Reconciliation Issue #4 - Realigned FM 1044 to IH 10

Guadalupe County	Seguin
1. Realign FM 1044 to meet with RM 775 at IH 10 as a 120-foot Arterial (R4 or U4M) 2. Widen FM 775 South of IH 10 within a 180 foot wide right-of-way	3. Seguin Outer Loop is a 6-lane divided Parkway in this vicinity

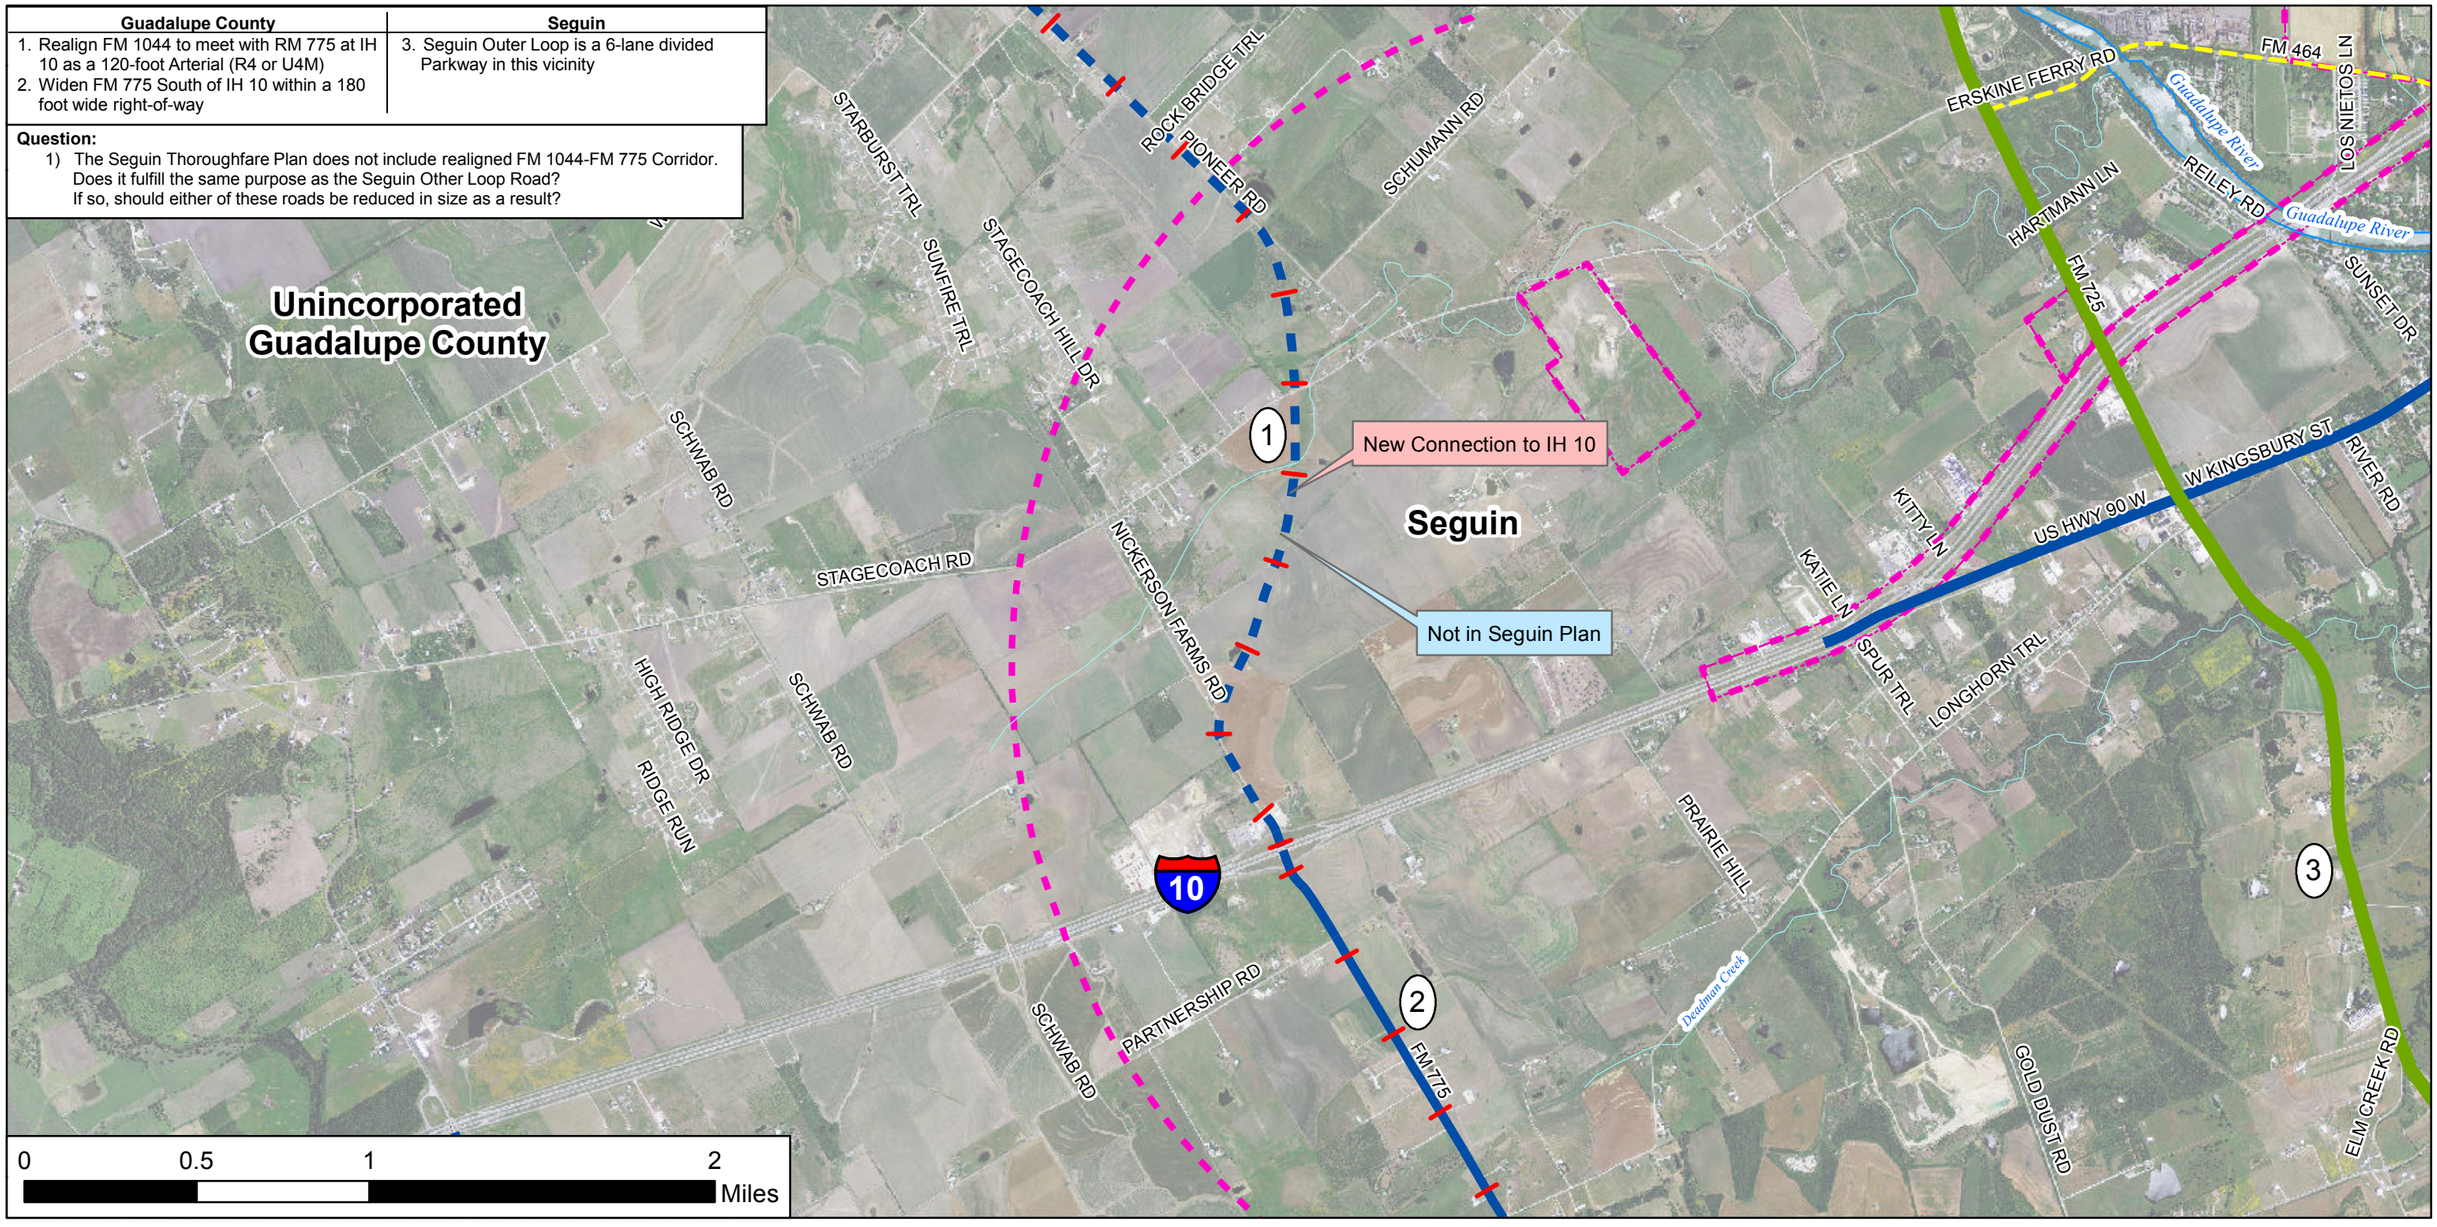
1) The Seguin Thoroughfare Plan does not include realigned FM 1044-FM 775 Corridor. Does it fulfill the same purpose as the Seguin Other Loop Road? If so, should either of these roads be reduced in size as a result?
